Thank you very much for your further evaluation and insightful comments on our manuscript "CRUX-1.0: An automatic GHG and Ozone observation system for inland Antarctica Plateau" [Paper #EGUSPHERE-2026-1227]. We sincerely appreciate the reviewers' guidance, which has helped us further refine and solidify the manuscript. We have thoroughly addressed each point raised and have revised the manuscript accordingly. A point-by-point response to the suggestions is provided below, and the corresponding revisions have been highlighted in yellow in the revised manuscript for clarity.

Reviewer #1 (Remarks to the Author):

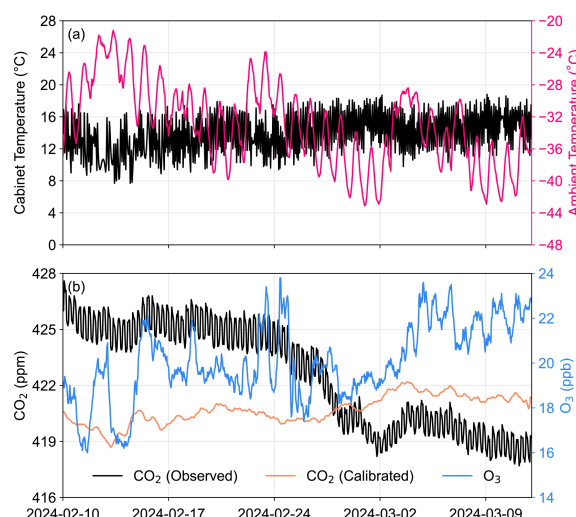
5. 1 Performance Comparison (Page 9 | Lines 407–436): The manuscript mentions the coefficient of variation of cabinet temperature (16%–20%). It is recommended to supplement the quantitative correlation analysis between temperature fluctuation and CO₂/O₃ measurement drift, and briefly explain whether this temperature fluctuation affects the measurement results.

Response: Thanks for your feedback. As detailed in Section 4.2 (Page 9 | Lines 438–446): cabinet temperature fluctuates by ± 2.5 °C (CV 16%–20%), which only induces maximum drift of ≤ 0.2 ppm/h for CO₂ and ≤ 0.1 ppb/h for O₃. These values are far below WMO/GAW accuracy thresholds, so the impact on final results is negligible.

As illustrated in Figure 4, the ambient surface temperature at Taishan Station fluctuates widely between -45.0 °C and -20.5 °C with prominent diurnal cycles, whereas the active thermal cabinet limits internal instrument temperature within 8.0–19.0 °C with a CV of 16%–20% (± 2.5 °C fluctuation). Comparative time-series analysis of CO₂ and O₃ in Figure 4b confirms that such cabinet temperature variation only yields tiny measurement drift (≤ 0.2 ppm/h for CO₂, ≤ 0.1 ppb/h for O₃), with no significant impact on measurement results.

Fig. 2: Multiyear monthly average temperature (a), relative humidity (b), atmospheric pressure (c), wind speed, and wind direction (d, e) at Taishan Station.

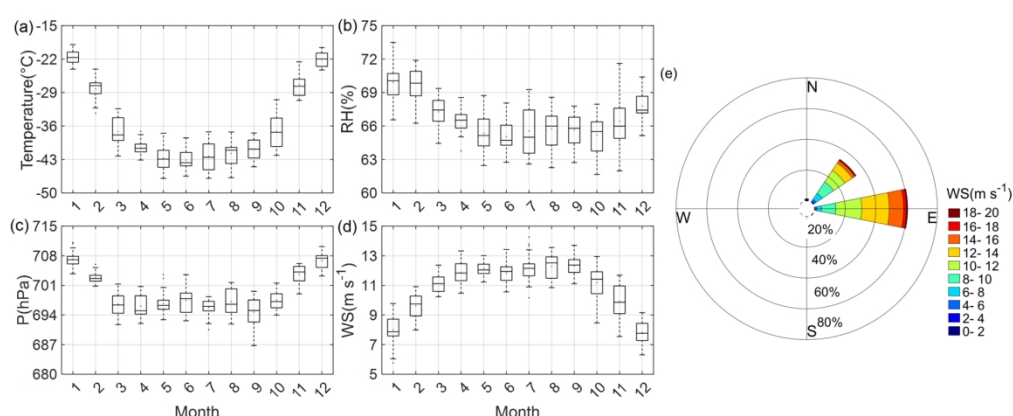
- Figure 2:** The numbers (axis labels and legends) are very small and difficult to read. Please increase font size for better legibility.

Response: Figure 2 has been redrawn with enlarged font sizes for all axis labels and legends.

Fig. 1 Geographical distributions of Taishan station

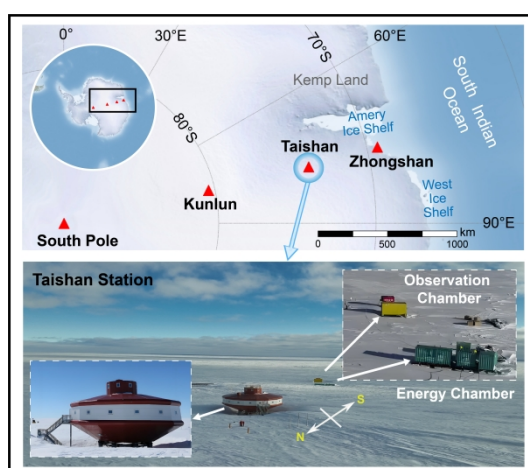
8. Figure 1: Missing north arrow and scale bar; please supplement them to comply with AMT's figure specifications.

Response: We have added a standard scale bar to Figure 1 as required. The existing latitude and longitude lines across the map can clearly indicate orientation, so a separate north arrow is not additionally added, which complies with AMT figure requirements.

Fig. 4 Compares synchronous in-cabinet temperature (black, left axis) and outdoor ambient temperature (pink, right axis) (a), hourly average concentration of observed CO₂, hourly average concentration of calibrated CO₂ and O₃ concentration transmitted from the

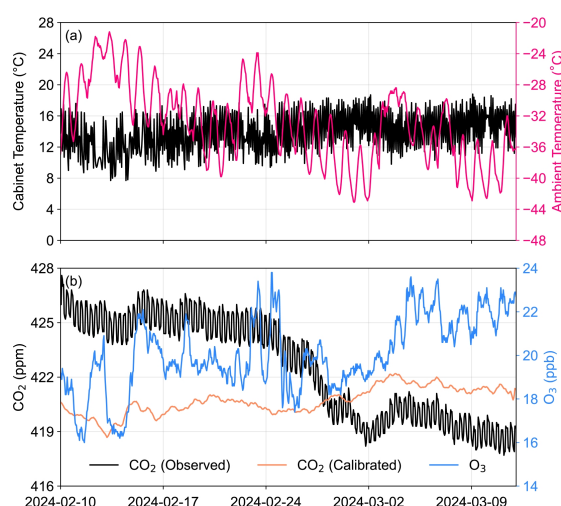
9. Figures 3–6: Missing complete axis units and poor legend contrast; please optimize them to improve readability.

10. In Figure 4, the authors should examine whether air temperature affects the instrument temperature, and whether there is any heterogeneous variation between the two.

Response: We replenish missing physical units for all coordinate axes of Figs.3~6, adjust legend font size and colour contrast to improve readability as required.

Response: Ambient temperature diurnal cycles cause mild periodic fluctuation of cabinet temperature, but the active heating system limits internal variation within ± 2.5 °C. As detailed in our response to Reviewer #1, Comment 5, this fluctuation has negligible impact on measurement results.

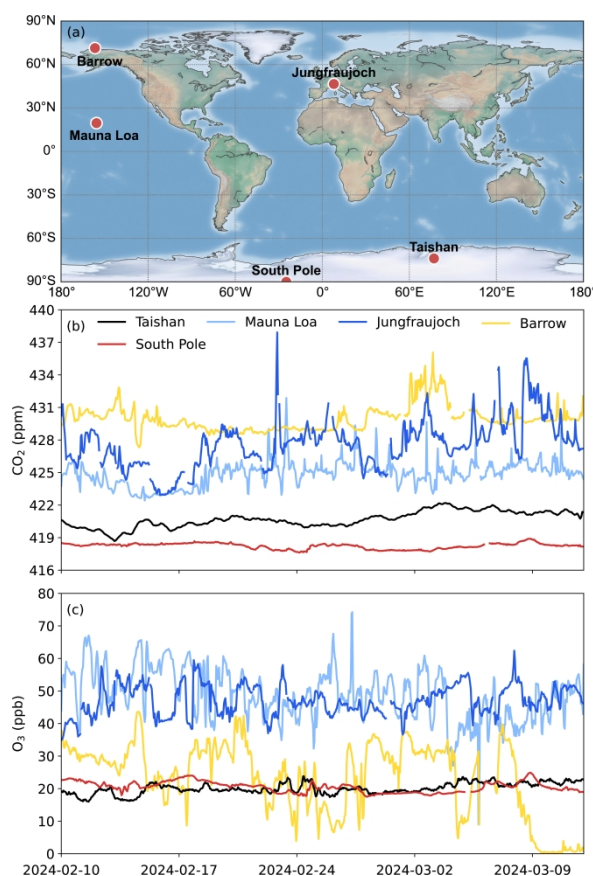
- Figure 6:** What specific insight does the comparison of continuous measurements from all five stations provide? The purpose of this figure should be more clearly stated in the caption and main text.

Mauna Loa, and Jungfraujoch as reference stations. The authors should clarify the selection criteria and explicitly describe how these sites support the study's global comparability analysis, in order to strengthen the rationale of the comparative design. In addition, Figure 6 includes data from Barrow, Mauna Loa, and Jungfraujoch, which represent a mix of background and more anthropogenically influenced environments. The rationale for combining these different site types requires further explanation. Otherwise, it remains unclear why other background stations (e.g., Svalbard and Waliguan) or additional urban datasets were not considered.

Response: We greatly appreciate this constructive comment. We have revised the caption and main text (Section 5.2) to explicitly state the three purposes: (1) validate the reliability of CRUX-1.0 measurements; (2) quantify regional differences between polar and mid-latitude background atmospheres; (3) demonstrate the value of unattended systems in complementing the global observation network.

Response: We greatly appreciate this constructive comment. The stations are selected to cover representative background atmospheric environments (Antarctic inland, Antarctic coastal, Arctic coastal, mid-latitude marine, mid-latitude alpine) and all have long-term WMO/GAW certified data records, enabling global representativeness verification and cross-regional comparison. This rationale has been added to Section 5.2.
